Request for Class II Permissive Change

FCC ID: VG8XM820CYY-PM Data: 2012-5-13

Please be notified that we, the undersigned, Guangdong Midea Microwave and Electrical Appliances Manufacturing Co.,Ltd. declare that the reasons for this class II permissive change are as below:

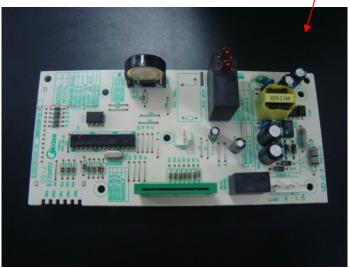
Updated Mainboard as below: 1、

Changed linear power supply to switching power supply

or below switching power supply.

Between of linear power supply and switching power supply have the same specfication of rated output power, changed to the switching power supply, theirs rated output power have not obvious change.

The differences of between this two switching power supply only is PCB layout and components location, anything else are the same.
